Corps of Engineers comments on the Environmental Assessment are presented below. The attached spreadsheet is provided to summarize Corps comments on prior documents and license application drafts.

**Re: Mahoning Hydroelectric Project (FERC No. 12555)  
Applicant's Response to Comments Filed by USACE and PA Fish and Boat  
Commission on Environmental Assessment**

I am writing in response to the Notice of Availability of Supplemental Environmental Assessment (EA) filed on October 20, 2010 for Mahoning Creek Project No. 12555-004. Our comments on the original EA were filed on April 23, 2010. The transmittal letter for those original comments noted three major concerns that summarized in large part the detailed comments in an enclosed memorandum. These concerns were: potential impairment of our ability to meet our water quality and environmental stewardship mission with the stipulated minimum flow of 30 cubic feet per second (cfs); lack of sufficient technical analysis of the potential impacts to water quality and aquatic resources to support the conclusion of a Finding of No Significant Impact (FONSI); and the failure to analyze a sufficient range of alternatives that would better d

Figure 1

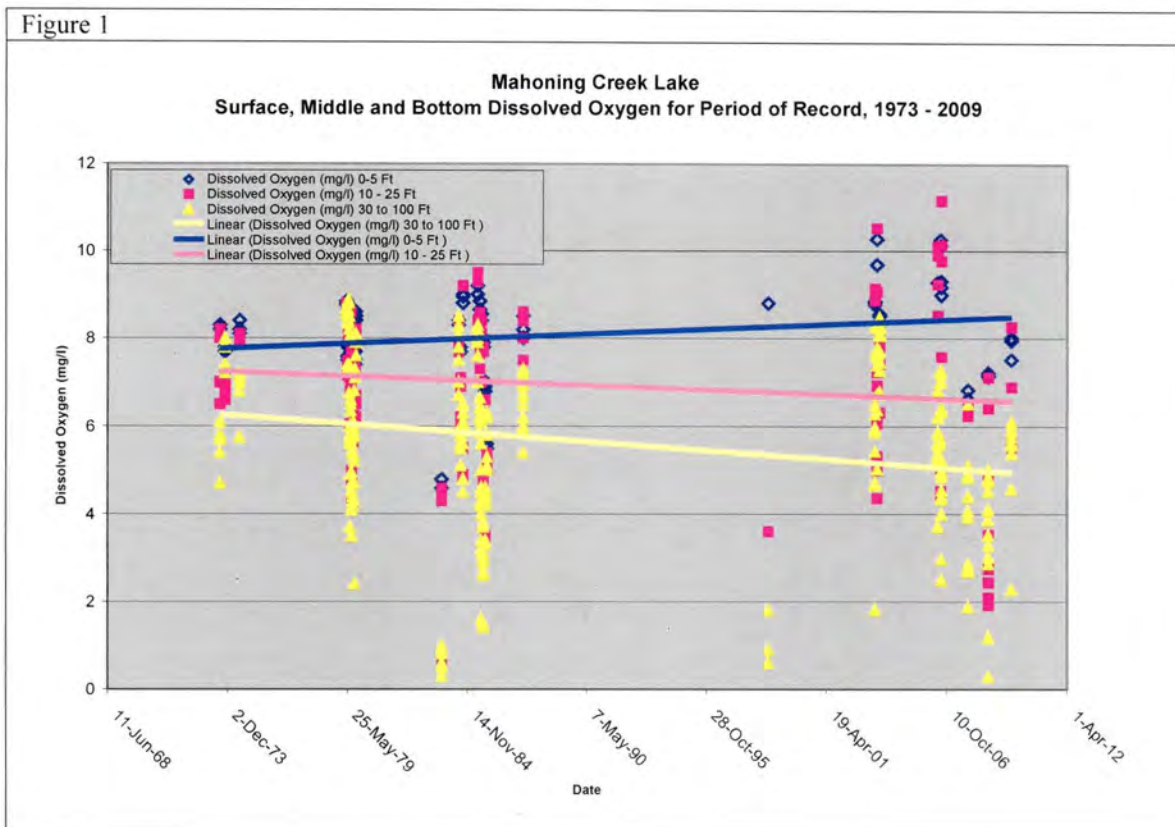
Dissolved oxygen vertical profile data for Mahoning Lake at the deepest location just upstream of the dam for our period of record are presented in Figure 1, and the same data sorted by depth are presented in Figure 2. Outflow dissolved oxygen and water temperature data (sorted by water temperature) are presented in Exhibits 3 and 4, respectively.

As can be seen in Figures 1 and 2, lake dissolved oxygen levels are generally  $> 5$  mg/l at depths  $< 25$  feet although there is a general trend towards decreasing DO levels in the lake hypolimnion (30 - 50 ft) over the period of record. The average lake surface DO (0 to 5 ft) is 8.9 mg/l, the average mid-depth DO (10 to 25 ft) is 7.0 mg/l, and the average lake bottom DO (30 to 100 ft) is 5.7 mg/l. As can be seen in Figure 3, the lowest outflow DO reading for the entire period of record was 7.2 mg/l in 1979, and these data show a general increasing trend. Figure 4 demonstrates that outflow water temperatures do not exceed 80 Degrees F.

Figure 5

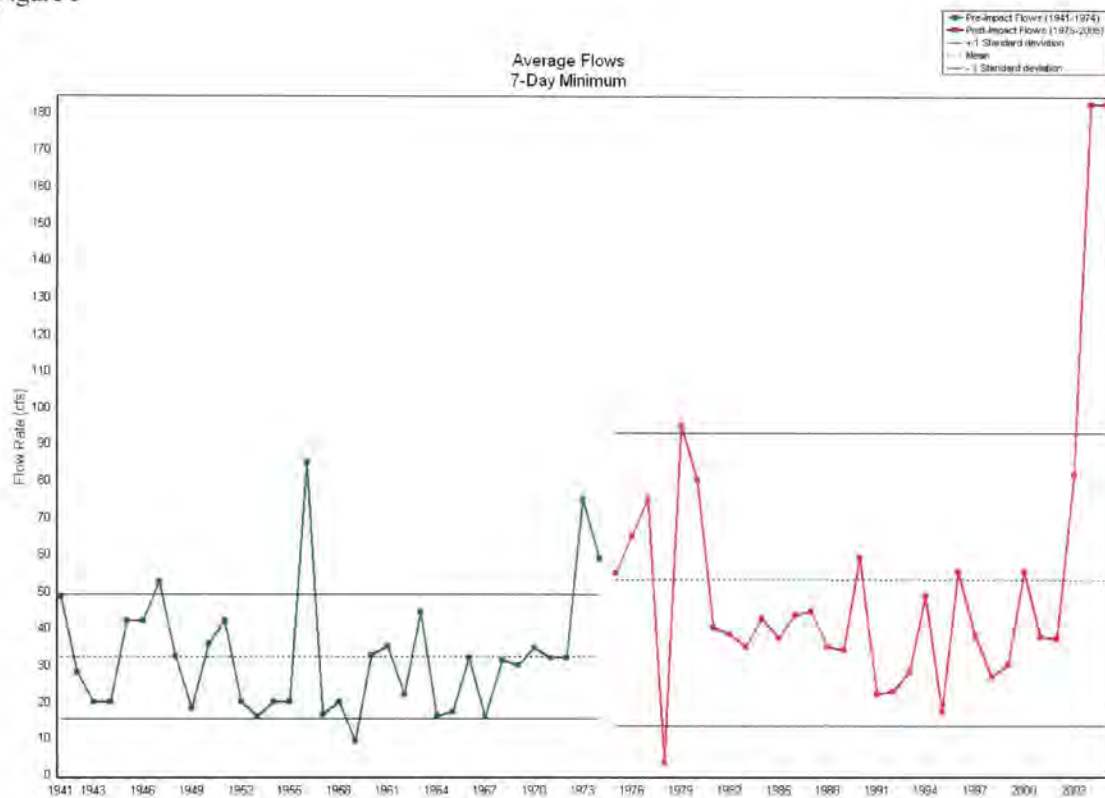
interpretation of the meaning of Q7-10; it appears that this concept is being interpreted differently by MCHC and the Corps. Page 19 of the EA includes a footnote defining Q7-10 as “the lowest flow which has occurred on a given stream reach for seven consecutive days over the previous 10-year period of record”; the USGS defines it as “the average minimum streamflow expected for seven consecutive days once every ten years”; and the EPA defines it as “the seven-day, consecutive low flow with a ten-year return frequency; the lowest stream flow for seven consecutive days that would be expected to occur once in ten years”. The differences in wording may be small, but we would like to stress that Q7-10 is not the 7-day low flow from the previous ten years and MCHC’s reference to a ten-year period ending on September 30, 2008 is in error since the Q7-10 is not based on a specific ten-year period.

The use of the calculated Q7-10 as a bypass flow is not appropriate because it does not address seasonal requirements or impacts of a permanent low flow on water quality and aquatic life in the stilling basin. As we commented in our review of the Application for New License, the proposed 30 cfs bypass flow will not adequately protect stilling basin water quality and aquatic life; will increase lake sedimentation since hypolimnetic releases will be reduced; will increase sedimentation in the stilling basin and degrade stony bottom habitat; and is too low to minimize impacts of a higher intake elevation on lake and downstream water temperatures. Therefore, we will require that the Operations
